SITE PLAN REVIEW AND APPEARANCE BOARD

7th Avenue Banyan

Meeting	File No.	Application Type
January 25, 2023	2022-092-SPF-SPR-CL5	Class V Site Plan with Waiver
Applicant / Property Owner		Authorized Agent
West Atlantic Development Company, LLC		John W. Szerdi, LEED AP of Living Designs Group Florida Architects, Inc.

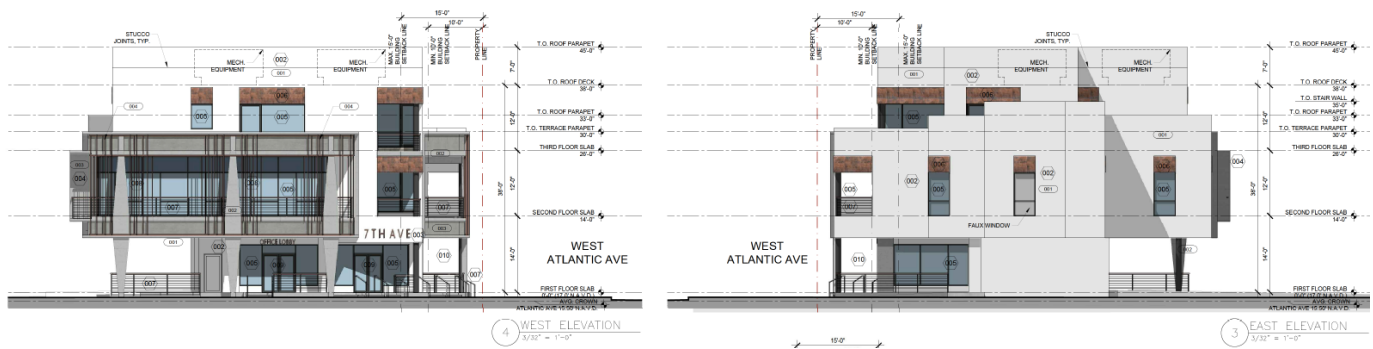
Pursuant to **LDR Section 4.4.13(6)(c)**, the maximum height of a parapet wall shall be six feet or sufficient height to screen all roof mounted equipment, whichever is greater. The parapet above the third floor is seven feet in height, necessary to screen the rooftop mechanical equipment. The blank treatment of the parapet, however, is without a banded detail to terminate the top and solidify the building on the ground, while breaking up the height of the parapet. The Board should consider if this additional detail, which is not inconsistent with the architectural style, should be added.
